THREE MILE ISLAND NUCLEAR STATION, UNIT 1

DOCKET NO. 50-289  
OPERATING LICENSE NO. DPR-50  
TECHNICAL SPECIFICATION CHANGE REQUEST NO. 5

Technical Specification Change Request No. 5

FIGURE 6-1

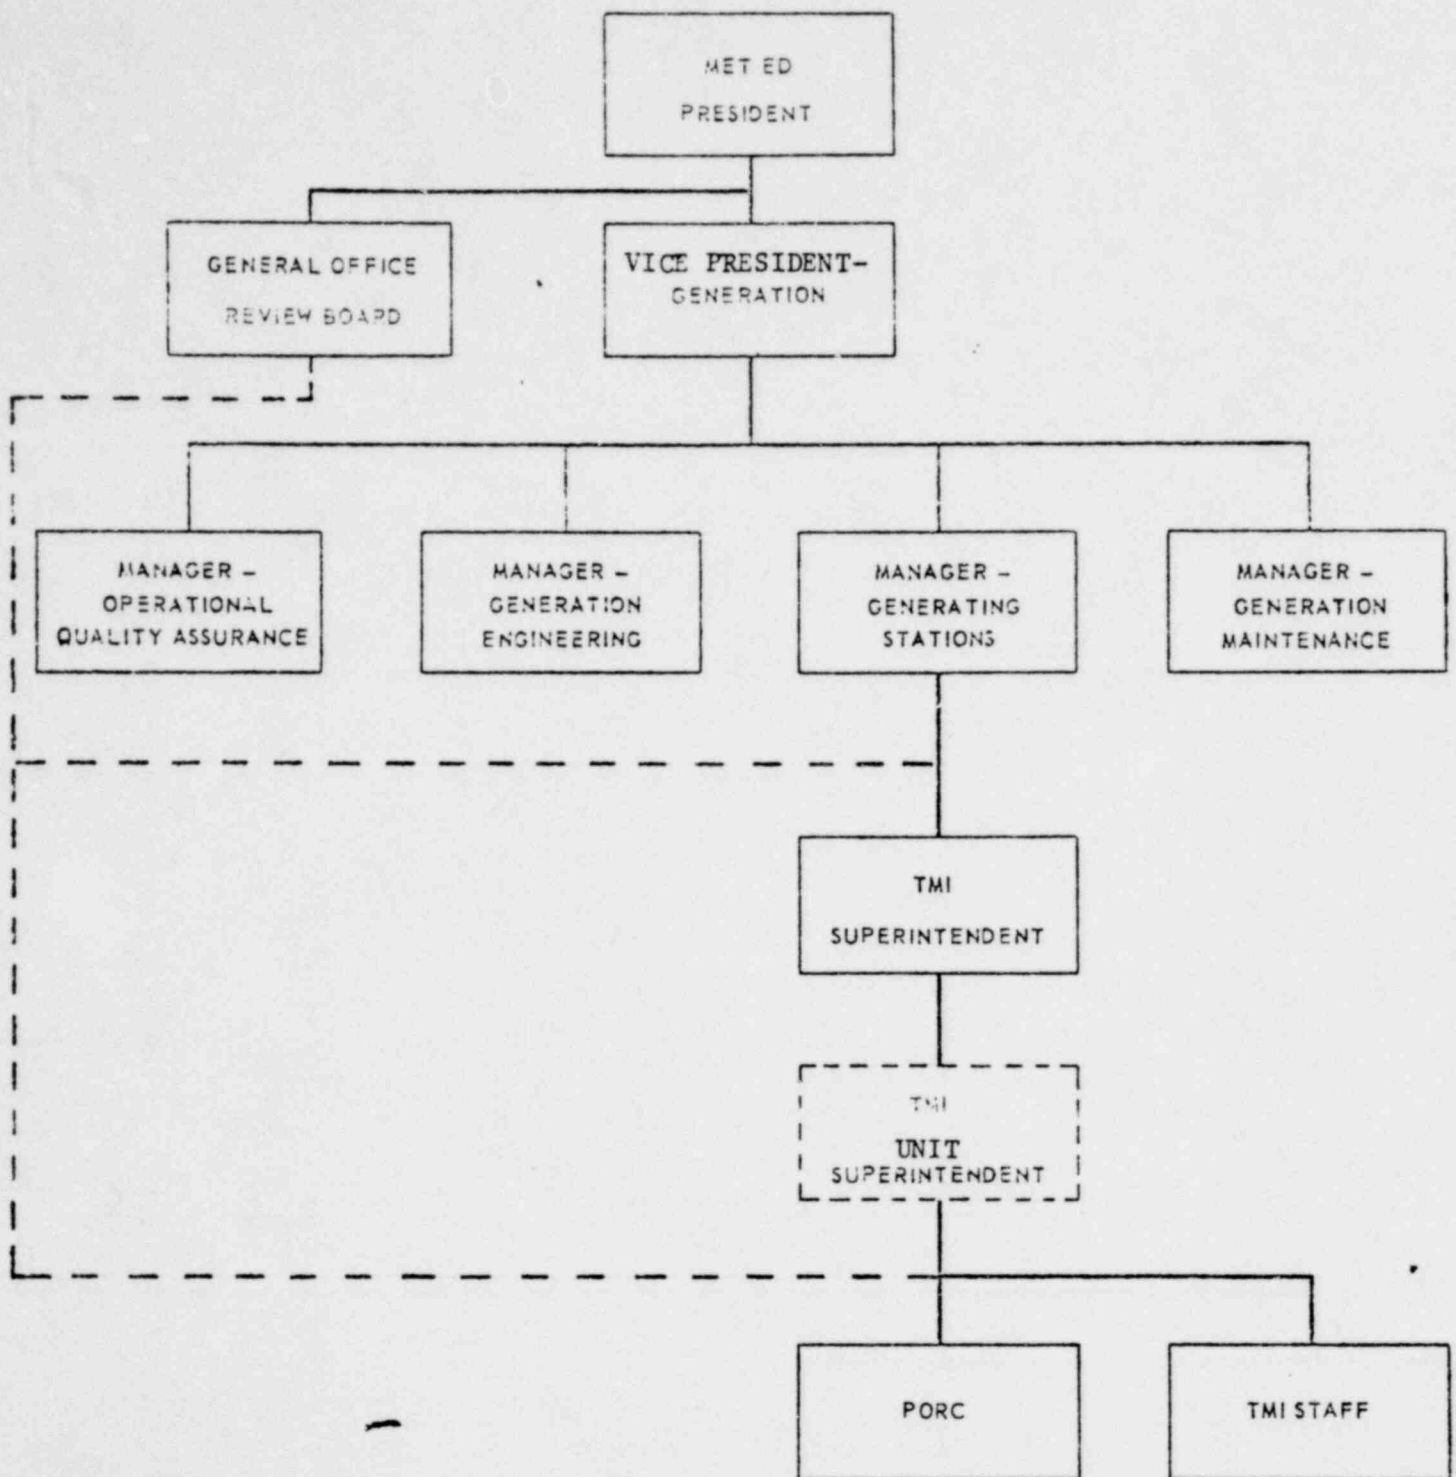
- 6.2.1 The organization of the Met-Ed Corporate Technical Support staff for Station management and technical support shall be as shown in Figure 6-1.

6.5.2.A.1 The organization of the Met-Ed Corporate Technical Support Staff is as shown on Figure 6-1 and consists of the Manager-Generation Engineering, Manager-Generation Maintenance, Manager-Operational Quality Assurance and their staff. The Corporate Technical Support Staff shall collectively have the competence required by ANSI-N18.7-1972, Standard for Administrative Controls for Nuclear Power Plants, Section 4.2.2 or the Vice President-Generation shall insure that deficiencies can be readily compensated for through the use of outside groups such as GPU Service Corporation staff, consultants, or vendors.
